**AGENDA
PLANNING COMMISSION OF THE
CITY OF WHITE BEAR LAKE, MINNESOTA
MONDAY, JANUARY 31, 2022
7:00 P.M. IN THE CITY HALL COUNCIL CHAMBERS**

To: The Planning Commission
From: Samantha Crosby, Planning & Zoning Coordinator
Date: January 31, 2022
Subject: Rose's Park View Addition – 1788 Highway 96, Case No 21-2-PUD & 21-1-P

**RESOLUTION APPROVING A
PLANNED UNIT DEVELOPMENT AND
PRELIMINARY PLAT OF
ROSE'S PARK VIEW ADDITION AT
1788 COUNTY HIGHWAY 96 EAST
WITHIN THE CITY OF WHITE BEAR LAKE, MINNESOTA**

FRONT ELEV #1 - DO NOT SCALE

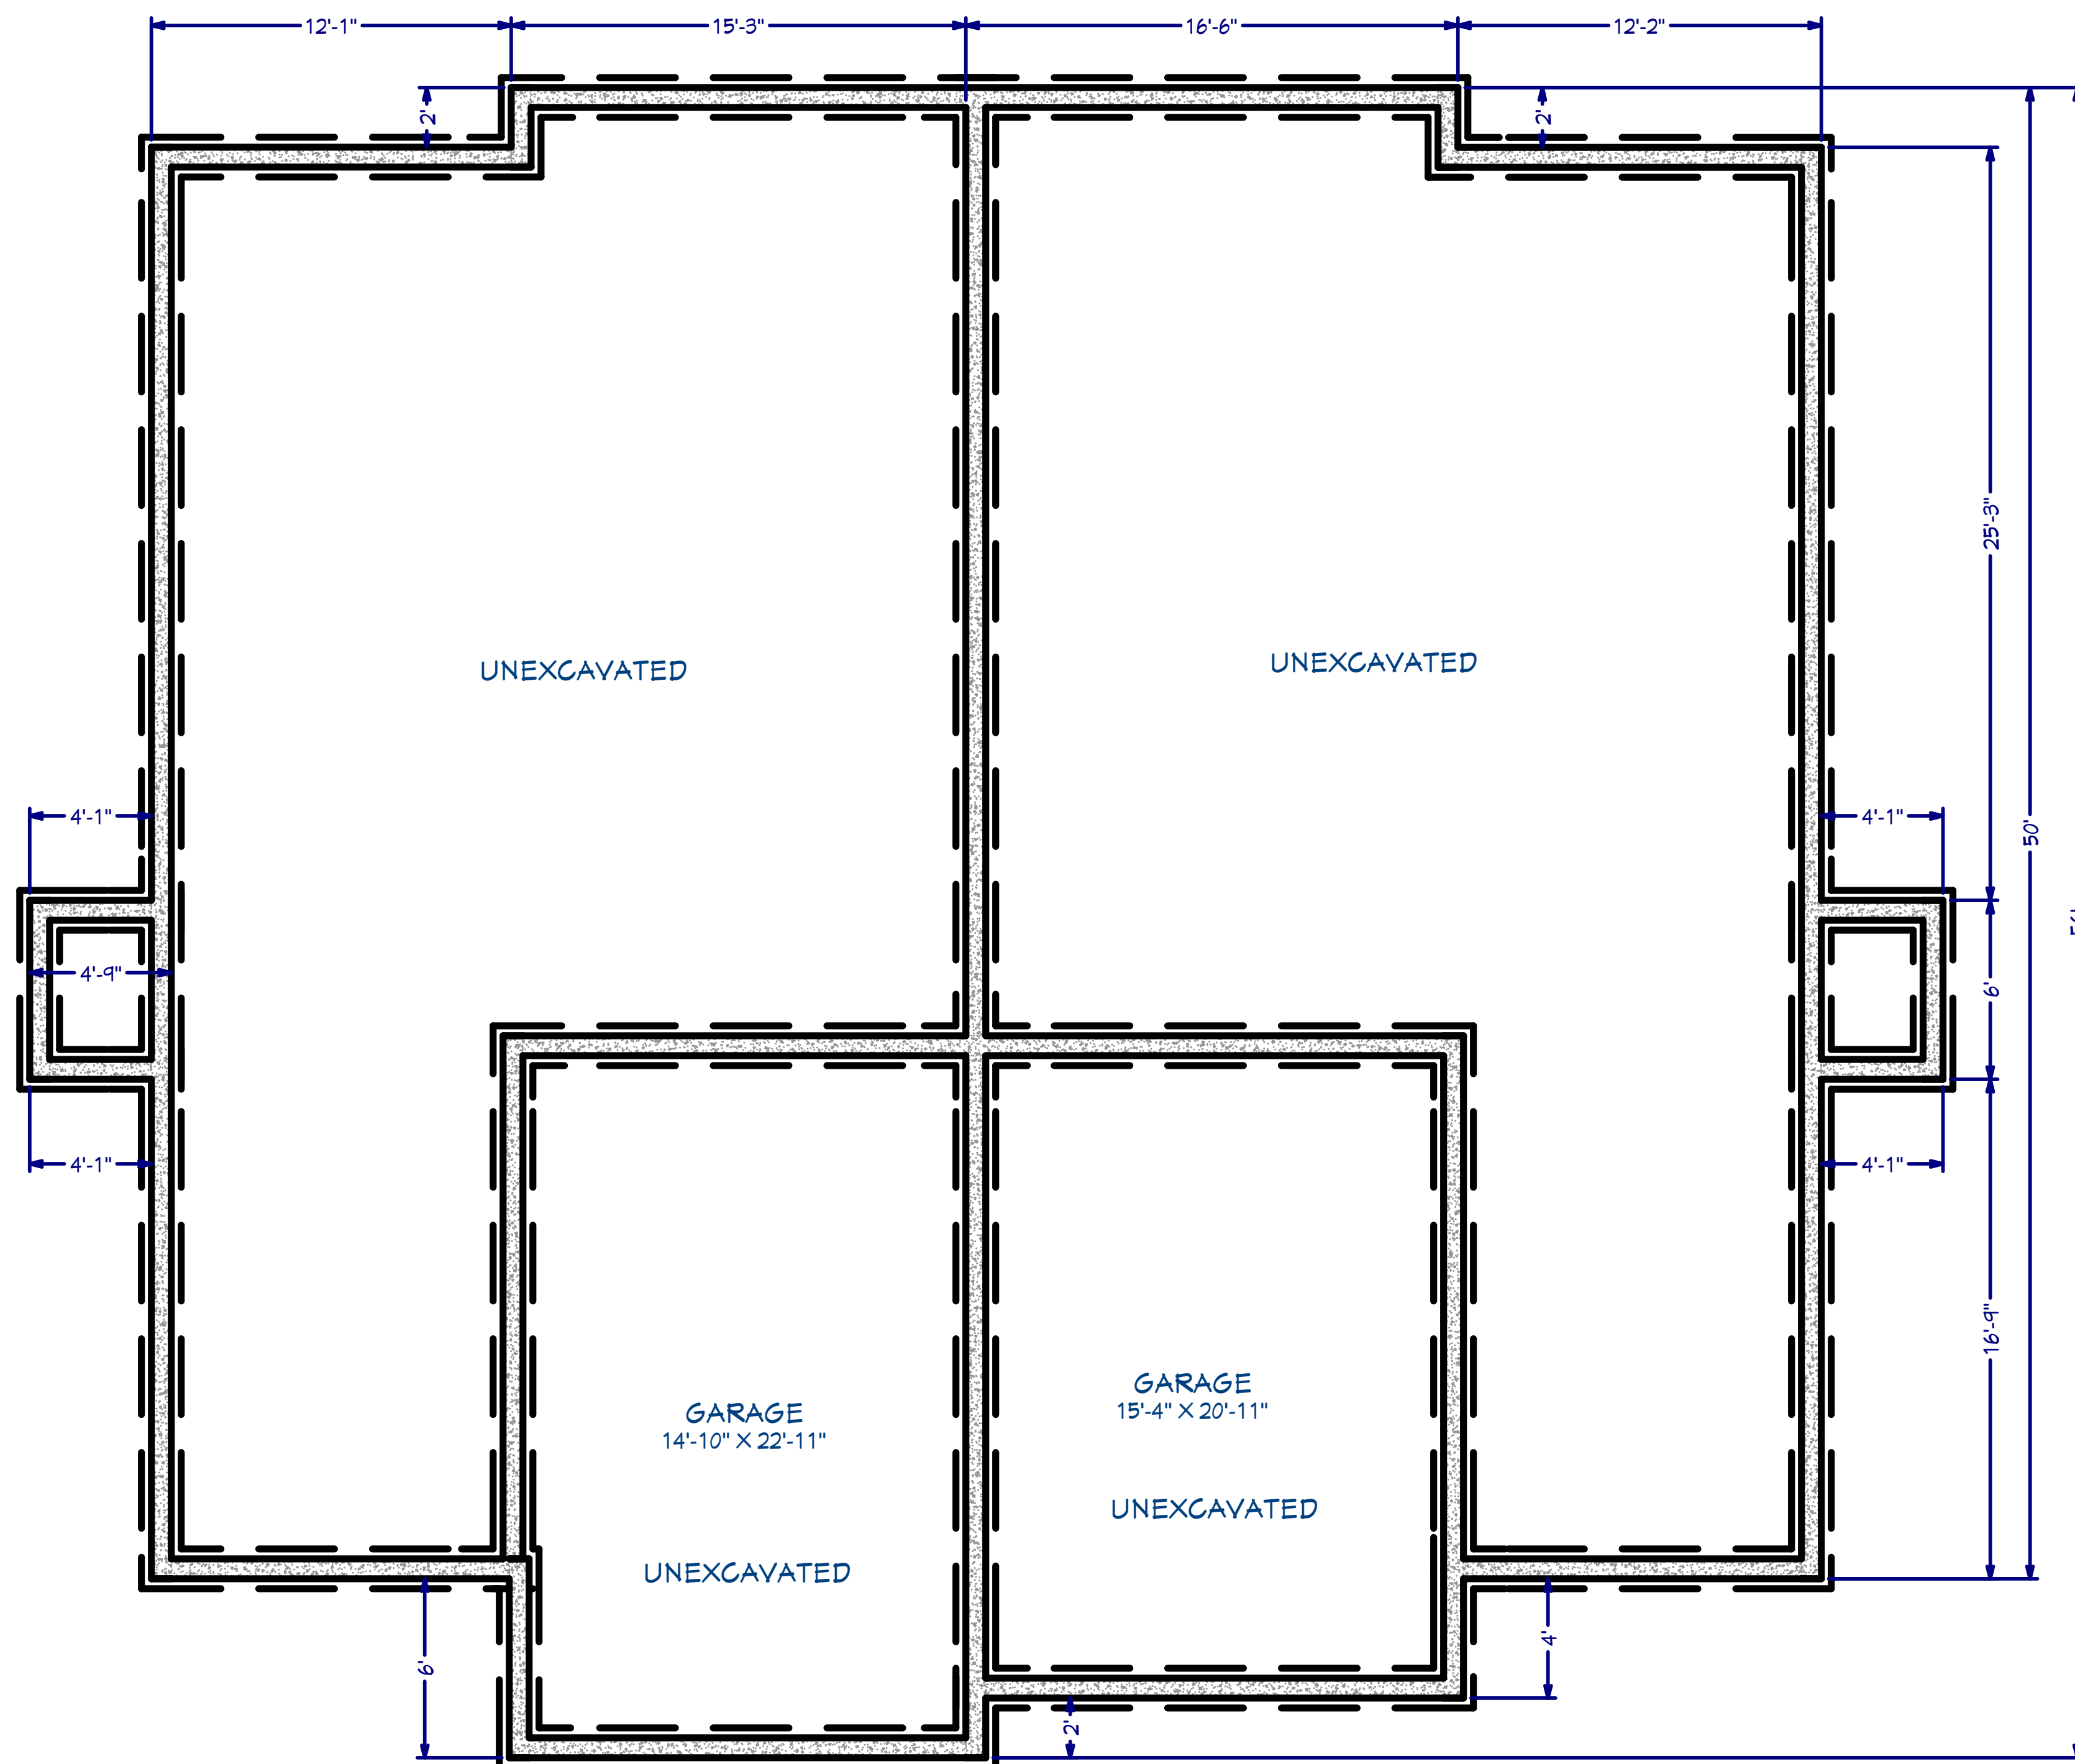
In an attempt to address the building appearance concerns expressed by the Planning Commission at the October meeting, staff has included two new conditions. First, since the garage is a forward-facing feature, that its design be enhanced with a non-stock/non-steel panel door with increased detailing and decorative wall-mounted light fixtures on either side of the garage door. Second, that the stone base be expanded to extend the full length of the front of the home.

9. **The building elevations shall be revised:**
 - a. **The garage door shall be a non-stock/non-steel panel door with increased detailing and decorative wall-mounted light fixtures on either side of the garage door.**

- b. **The stone base shall be expanded to extend the full length of the front of the home.**
10. The developer must dedicate public rights-of-way and utility easements as illustrated on the preliminary plan or as approved by the City Planner and City Engineer. Easements must also include an east-west easement between the end of the cul-de-sac and Columbia Park for pedestrian access.

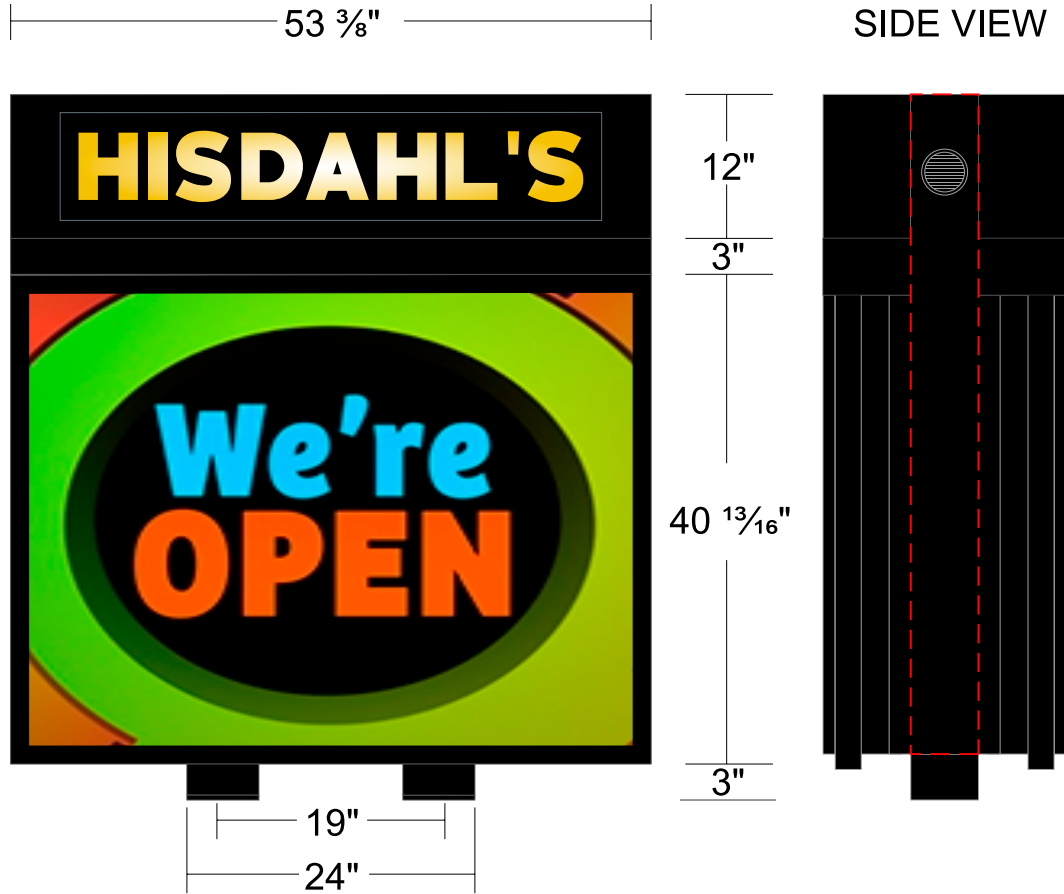
Since then, the applicant has worked with his sign company to revise the one issue with the sign's design – to combine the static portion and the dynamic portion into one sign "face". See revised graphic, attached.

4. The sign shall be redesigned to remove the space between the static portion and the dynamic portion of the sign.
5. All changes to the raingarden must be submitted to VLAWMO for review and approval. Proof of approval shall be provided to the City prior to issuance of a sign permit.
6. An overland overflow towards either the parking lot or the drive aisle shall be reestablished prior to the operation of the sign.

Scale: 1" = 20'
C1.11

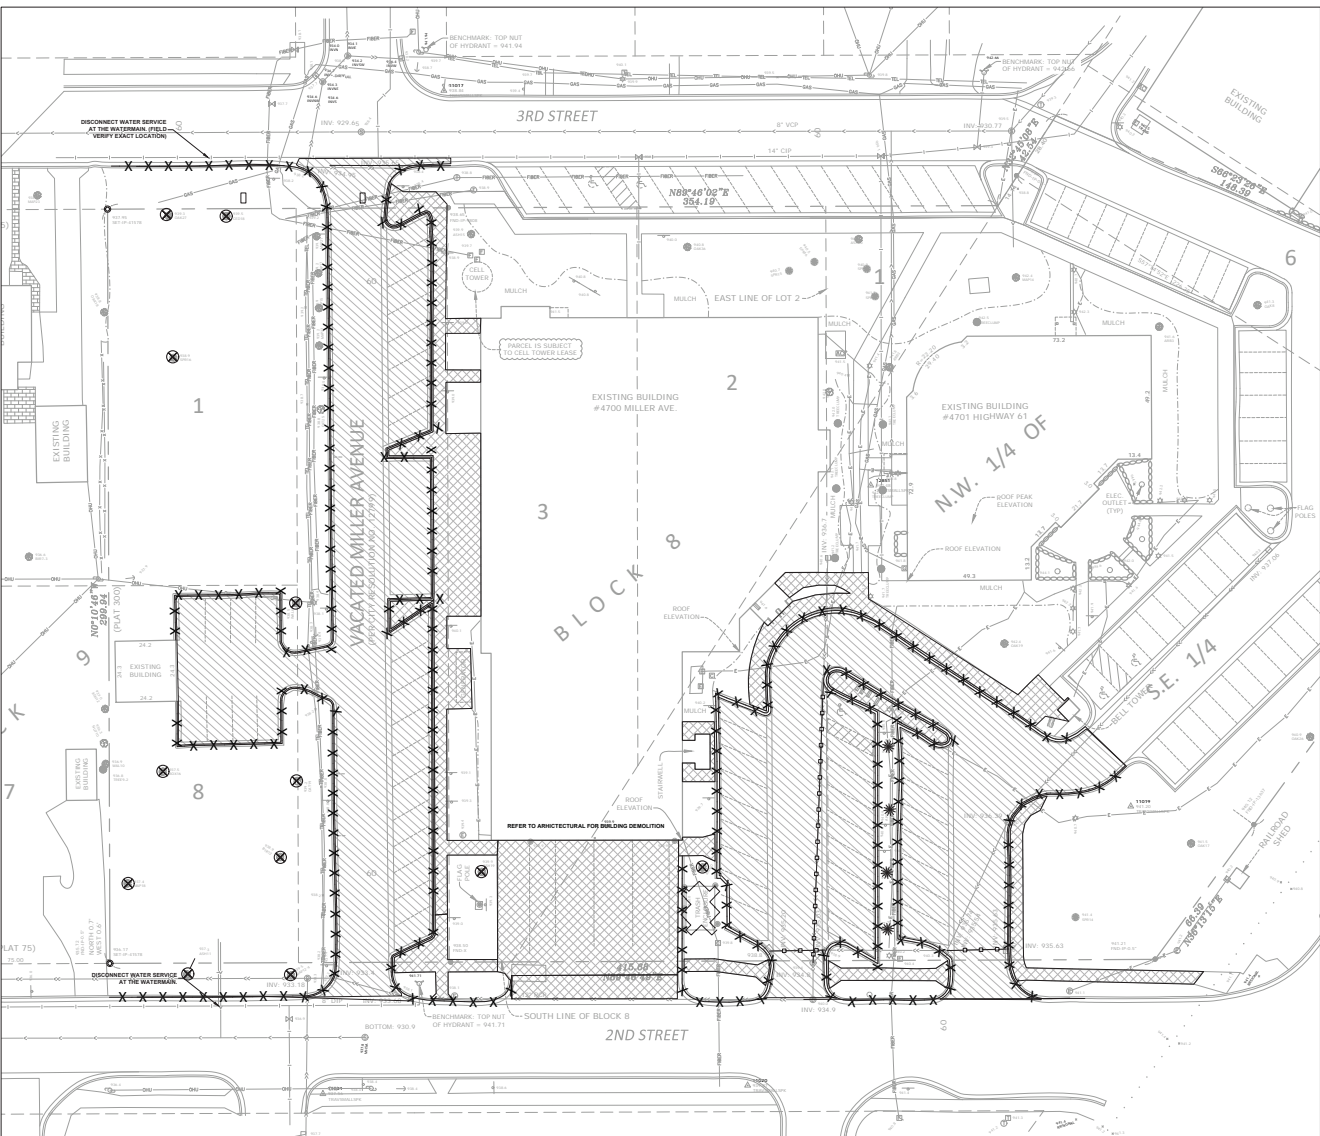
- 5) Revise the removals plan to include tree, building, trash enclosure, and other structure removals.
 - **The removals plan has been revised.**
- 6) 4701 Miller: disconnect water service on 2nd Street at the watermain.
 - **This has been noted on both sheets C1.11 and C1.41.**
- 7) 4709 Miller: disconnect water service on 3'd Street at the watermain. Show the general location of the water service on the plan and include a note to field verify.
 - **This has been noted on both sheets C1.11 and C1.41.**

- 14) Note the water service disconnects (comments 7j and 8,) on the utility plan.
 - **This has been noted on sheets C1.11 and C1.41**
- 15) Add a gate valve on the proposed water service to 3rd Street.

C1.21

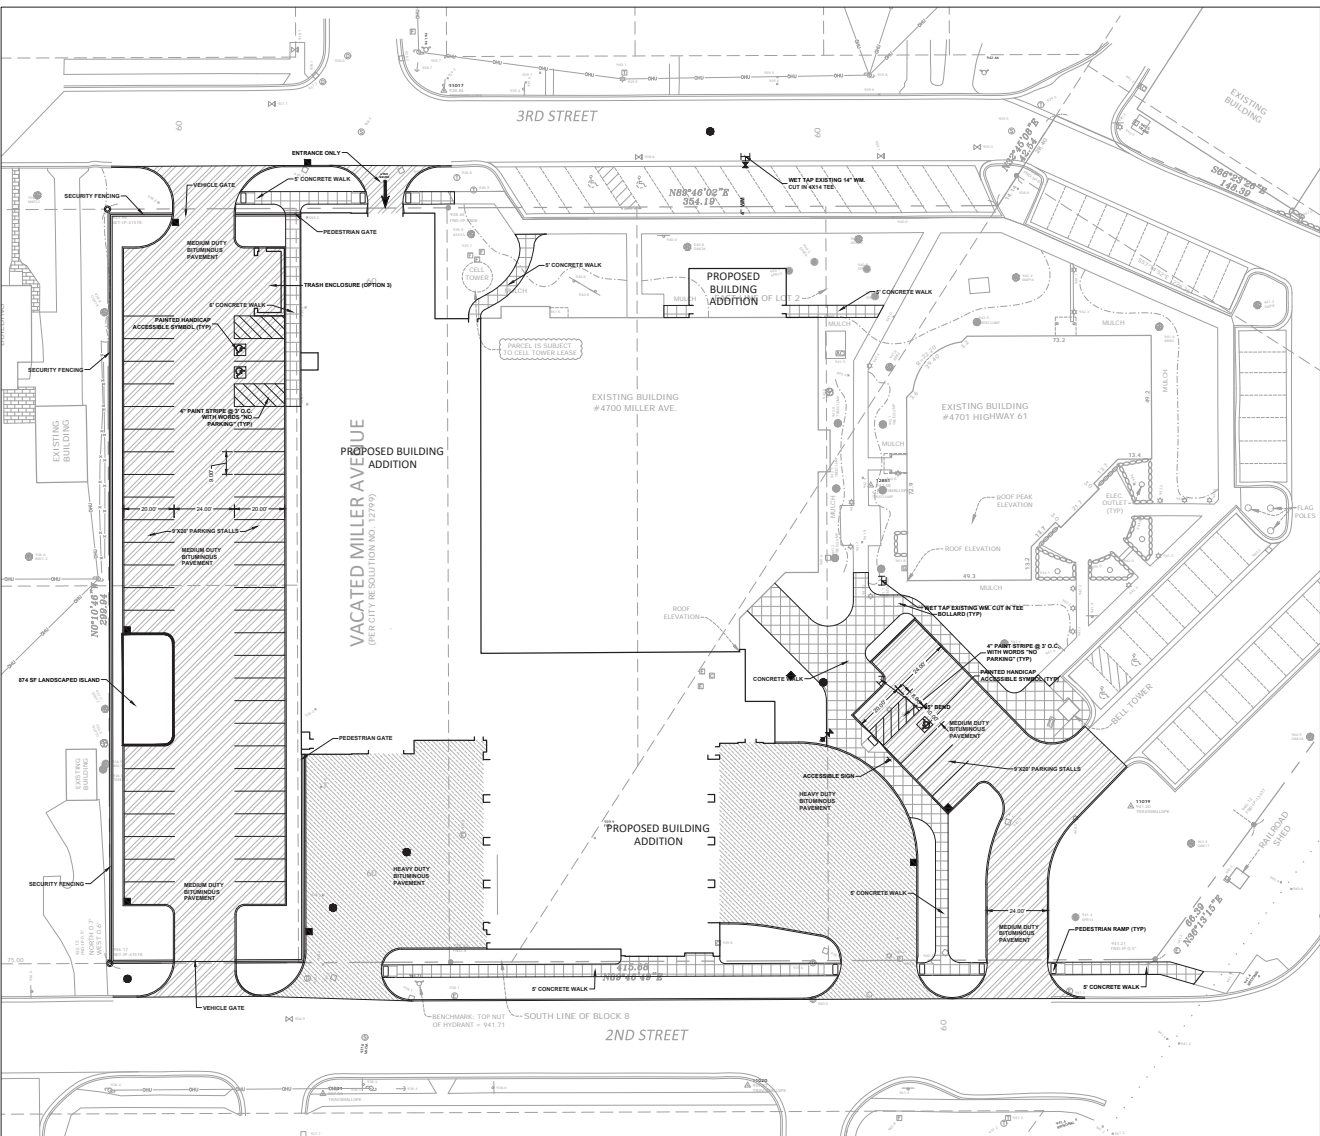
9. Please label the north side entrance to the parking garage as entrance only.
 - **This has been labeled on sheet C1.21**
10. Please disperse the handicap parking stalls so that some are in closer proximity to the north side entrance — depending on the final location and design of the dumpster, entrance location to police garage, and to accommodate City employees.
 - **All handicap parking has been shifted to the north to align with the updated door location near the secure parking.**

- **Please see sheet C1.21 for landscaping data calculations.**
12. Please remove the sidewalk in between the handicap stalls and replace with foundation low maintenance native plantings.

- **This has been updated on sheet C1.21/L1.11**
13. If the dumpster is re-located on the north side of the building, the area where the dumpster is currently located should be converted to greenspace.
